JUSTIFICATION

REAR EXTENSION

The following comments were received from the Heritage Officer regarding the original design of rear extension:

107 HIGH STREET, LINDFIELD, HAYWARDS HEATH, RH16 2HR

1. PROPOSED REAR ELEVATION

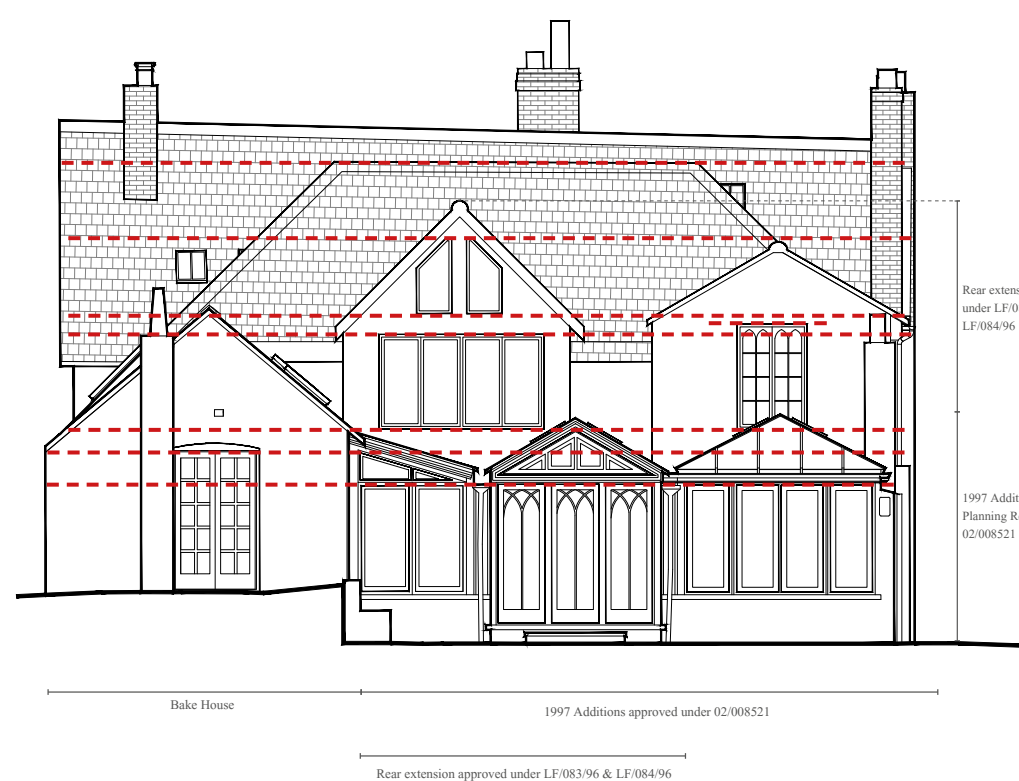
ANALYSIS:

- The proposal reveals greater amount of the original building as it is reduced in mass and demonstrate subservience. The original is more legible and harm caused by the unsympathetic 21st century extensions is undone.

- The new extension stands out clearly from the existing building emphasizing the new modern construction rather than attempting to blend it with the historic fabric

- The historic plan form is retained and legible in the extension at both ground and first floors
- The horizontal volume, spanning the full width of the existing house, presents a more linear and elegant form compared to the fragmented and disjointed collection of volumes on the approved scheme. There was two volumes prior to the planning approved scheme, within which the language of two forms was diluted, but the as built scheme re-instates the second subservient volume to the rear of the original 15th Century building fronting the high street, but with a flat roof instead of a pitched roof

- Victorian window and gable wall are concealed by new extension but exposed and celebrated internally
- The extension is reduced in height compared to the approved scheme, exposing more of the historic gable

- There are clear datum lines across the facade (refer to the analysis on following page) making it more visually appealing
- Composition of volumes is centralised and balanced

1. Rear elevation of the building prior to any works.

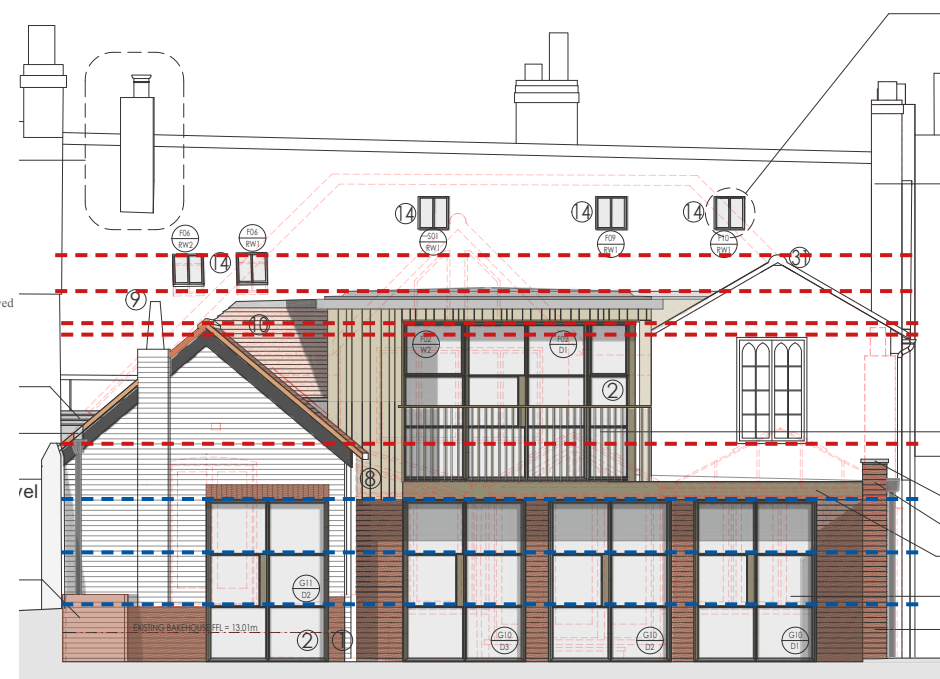
- The elevation is fragmented with no clear datums set by openings.
- One clear datum set by conservatories
- Chaotic composition of different types, styles and sizes of doors and windows

2. Approved rear elevation - submitted drawings under application DM/22/3694 & DM/22/3695 (planning approved).

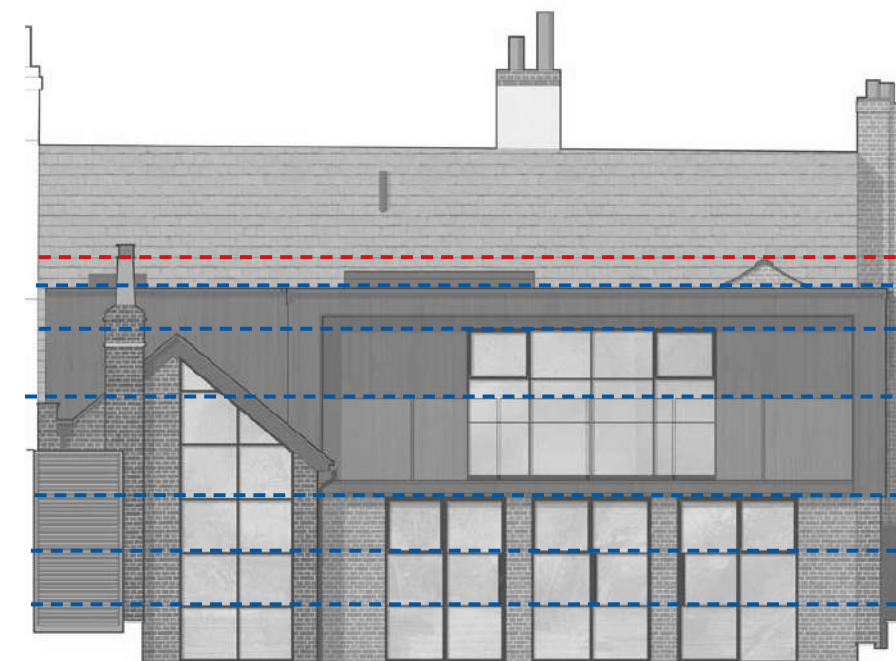
- The approved design demonstrates the same issue of fragmented elevation and lack of clear datums set by openings.
- One clear datum set by ground floor openings
- Several proposed and approved rooflights to the 15th century house roof add to the chaotic appearance of the rear elevations

3. Proposed rear elevation

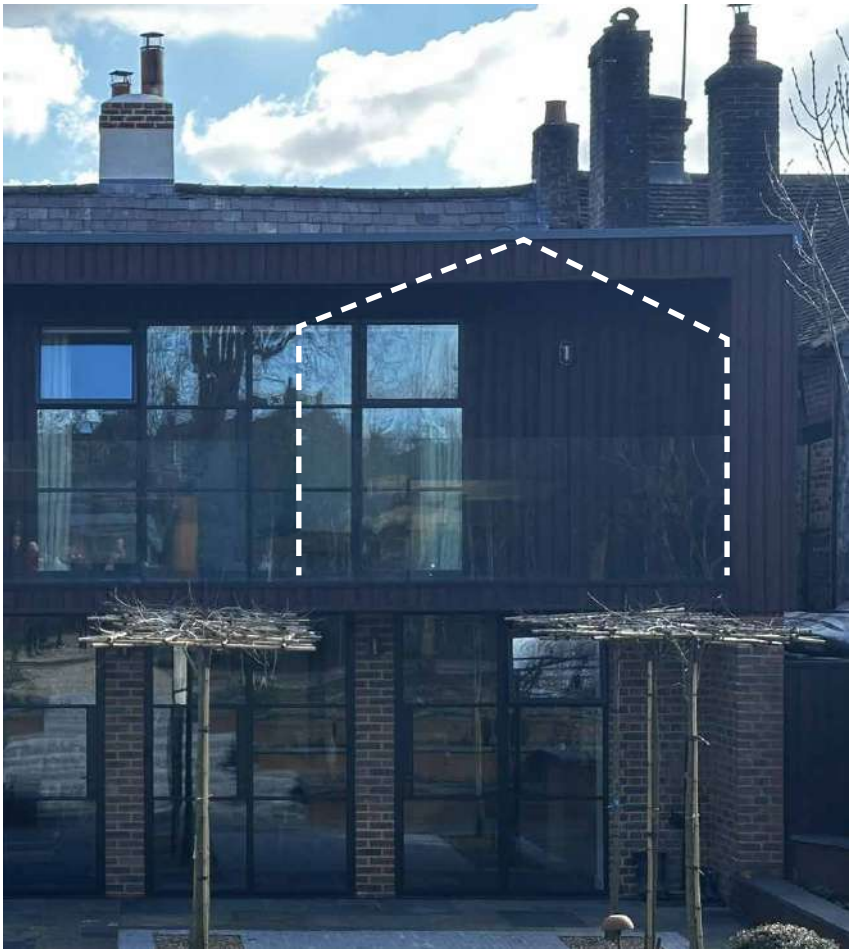
- The 'as-built' scheme demonstrates clear datums set both by massing of new extension and its openings. The elevation is unified, well considered and contemporary
- Approval of rooflights to historic roof was omitted, resulting in a less busy, elegant facade and less interference into historic fabric of 15th century house

‘As-built’ block plan, 45 degree rule diagram

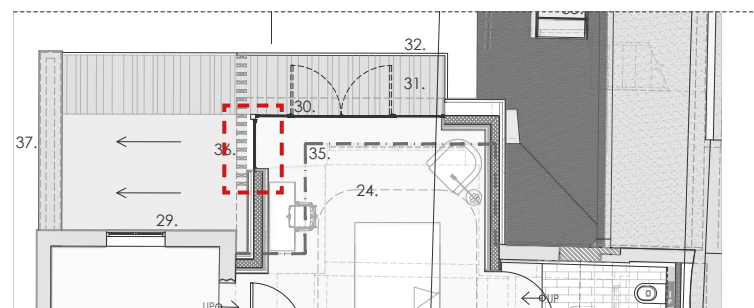
The 45-degree rule, derived from the Building Research Establishment (BRE) guidance, is a planning rule used to assess the impact of proposed extensions on a neighbour’s natural light, ensuring that new developments don’t unduly block sunlight into habitable rooms. The 45-degree rule was applied to determine if the ‘as-built’ extension blocks sunlight from entering a neighbour’s habitable room windows.

As demonstrated on the adjacent diagram, the first floor bedroom window amenity is also not affected by the rear extension.

1. Approved rear elevation - submitted drawings under application DM/22/3694 & DM/22/3695 (planning approved).

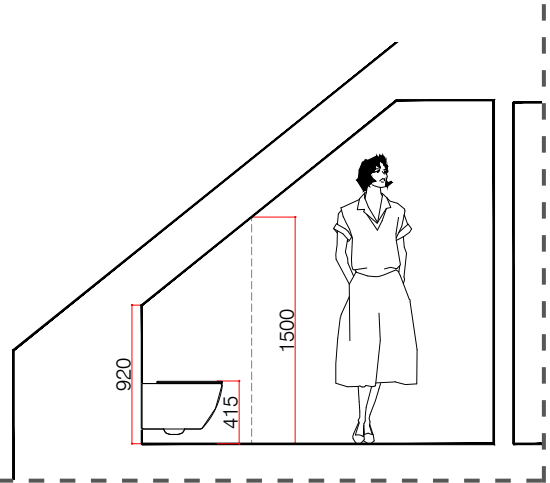
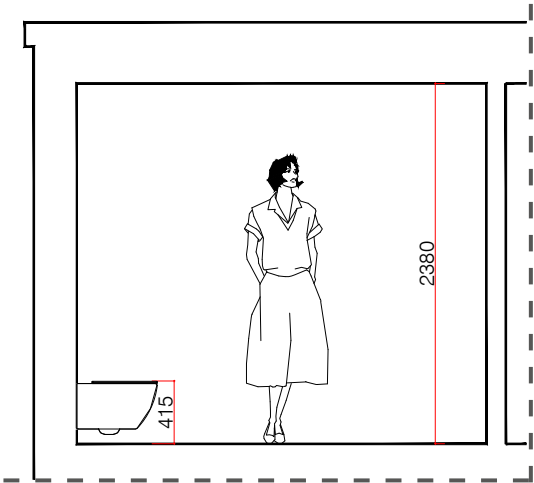
The approved scheme proposed the roof above the bathroom to be pitched, following the angle of the bake house roof. This would result in diluted significance of the bake house roof. In the contrary, the ‘as-built’ roof infill frames the roof of the bake house and allows it to clearly stand out.

As demonstrated on the adjacent section drawing, the approved scheme pitched roof above bathroom offers limited floor to ceiling height, making the space unusable. The minimum practical height at the lowest point (where the roof meets the wall) is typically around 1.5 meters. The flat roof solution mitigates this issue and improves the quality of space in a sensitive design manner.

First Floor Plan, Scale 1:100

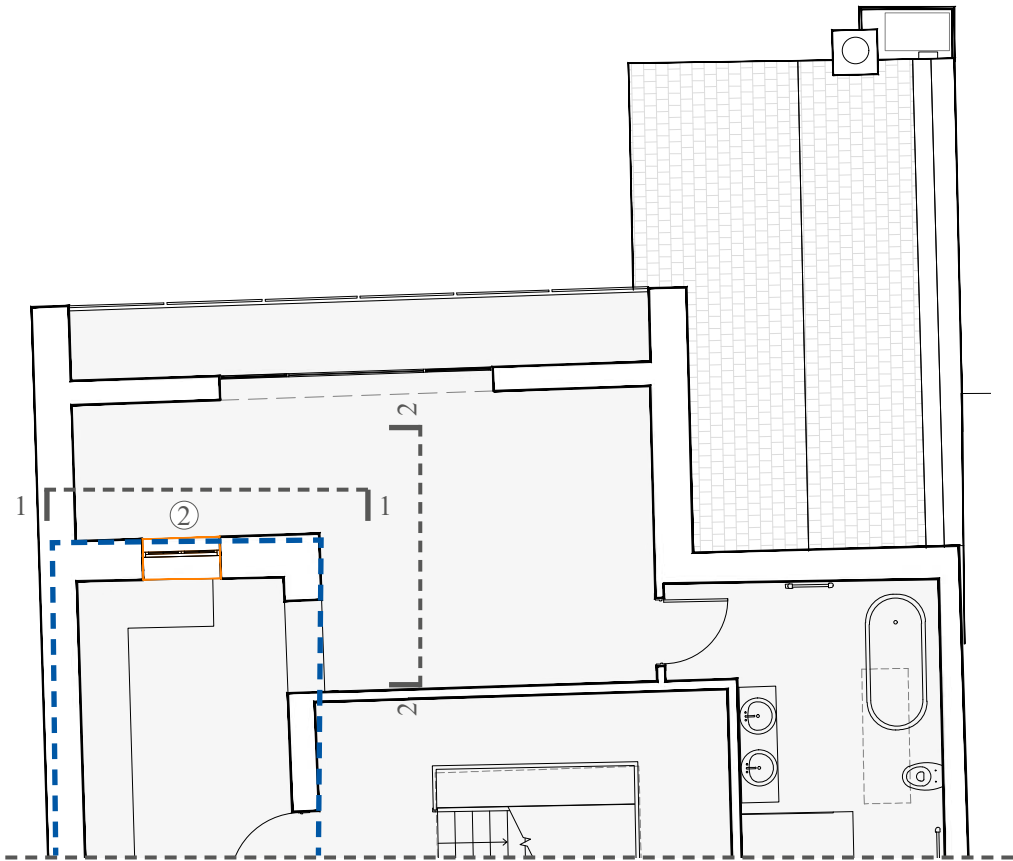
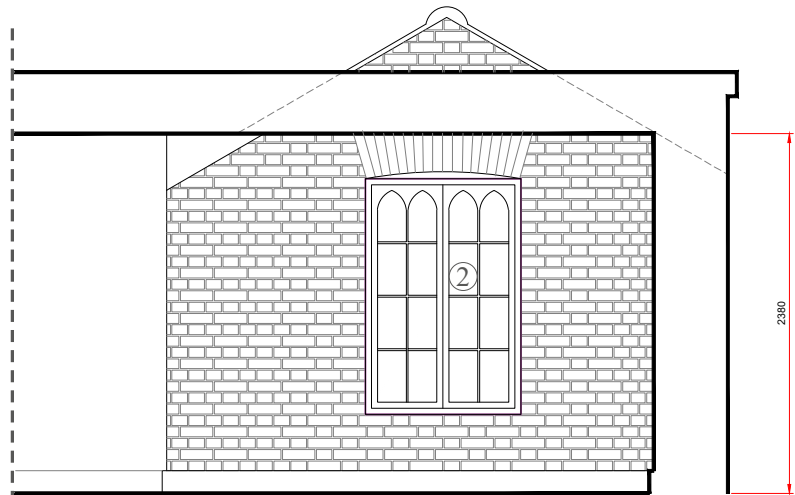
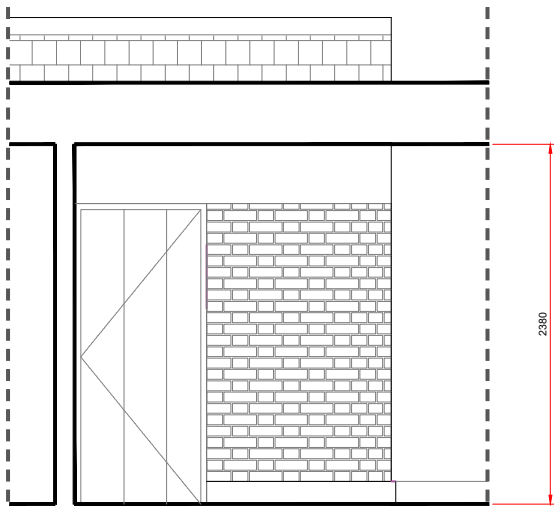
It is proposed under this application for the 1830s gabled outrigger to be internalised but exposed as an internal brick wall at first floor level with gothic style casement revealed in situ. This way, while concealed externally behind wall of the new extension, the reference to the historic gable is internally emphasised.

As presented on the adjacent photograph of the living room, the rear wall of the original 15th century elements of the dwelling is internalised. By following this design language, internalisation of the historic gable wall and gothic style window is in fact in accordance with the design language already present in the house.
